Title		
Schematic, Q&D, Lower Half Elex Board, Coastal Profiling Float		
Size B	Document Number <Doc>	Rev A
Date:	Friday, April 20, 2018	Sheet 1 of 1

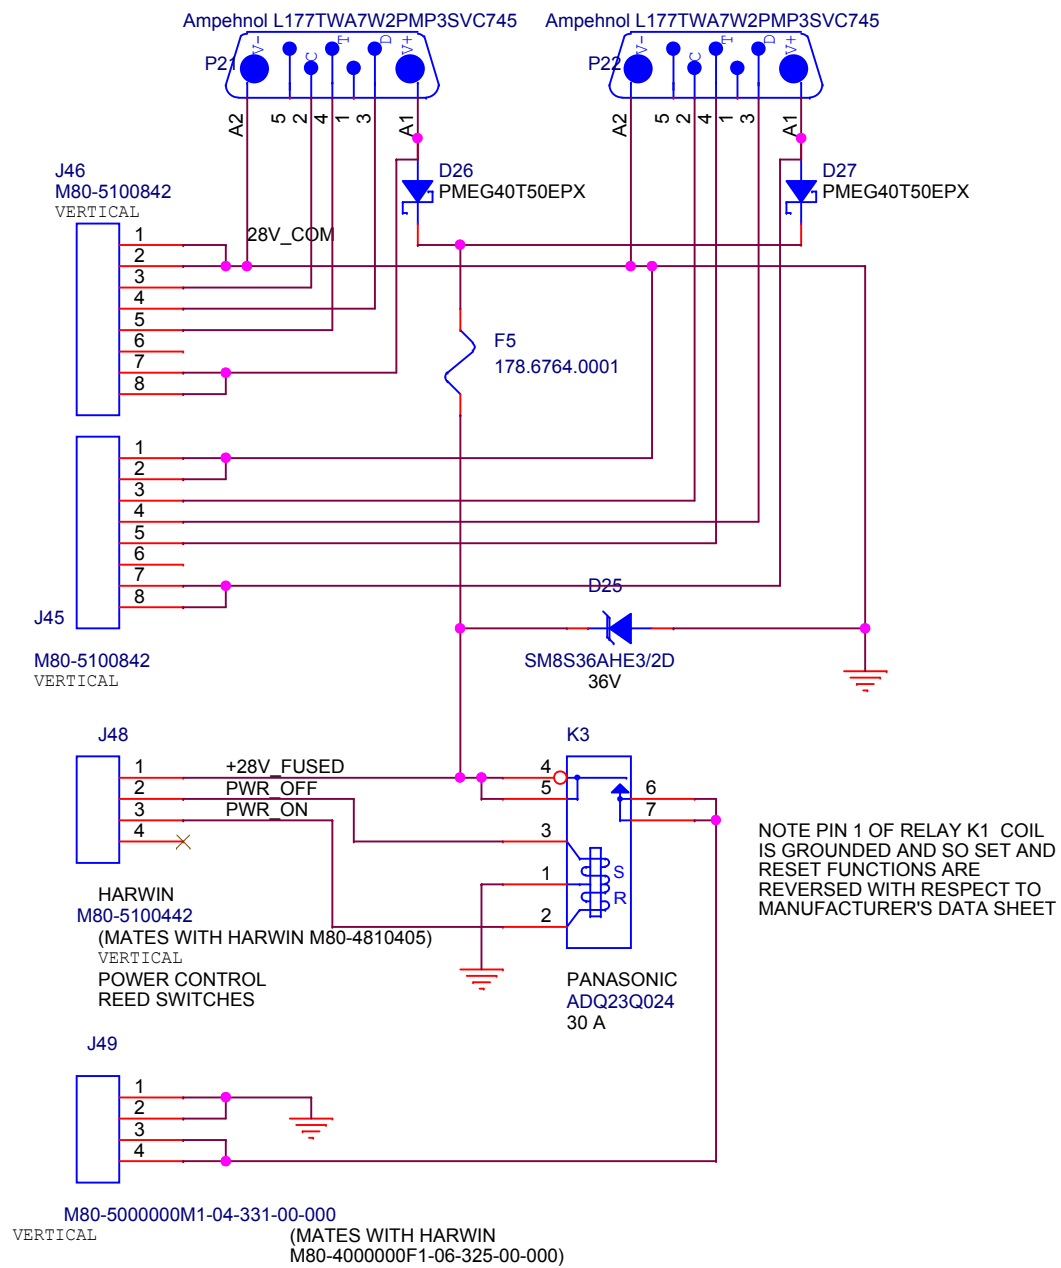
Rev A, 20 Apr 18: Move reed switch 28V feed to battery side of relay.
